INITIAL FIRE SAFETY INSPECTION REPORT

Debonair Limited Unit-2 (Extension)

RSC ID: 24580

Date: 09 April-2023

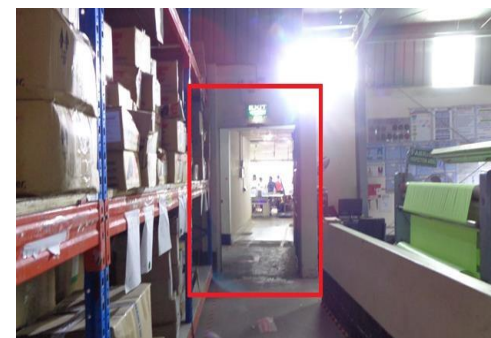
Table-1:				
SI No.	Category	Findings	Required Action	Remediation Time Frame
F-01	Fire Rated Construction	Storage room was not separated from other occupancy (production floor) Location: Ground floor in between Shed-1 to Shed-2.	Provide dedicated storage rooms separated by minimum 1-hr fire-rated construction. Where separate storage rooms are not feasible, provide defined storage areas and limit the storage arrangement as follows: - Maximum height of 2.4m and maximum area of 23 m ² - If sprinkler protected: maximum height of 3.66m and maximum area of 93 m ² Separate areas of unenclosed combustible storage by a minimum clear distance of 3m.	Within 3 months

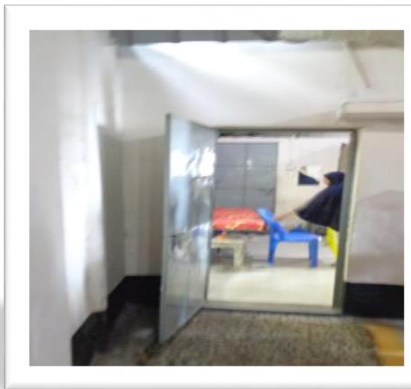
F-02	Fire Rated Construction	Daycare room was not properly separated from storage area(Shed-2)	Provide the daycare room's separation by minimum 3-hr fire-rated construction. Location: 2nd exit was non- rated.	Within 3 months
------	-------------------------	--	--	-----------------
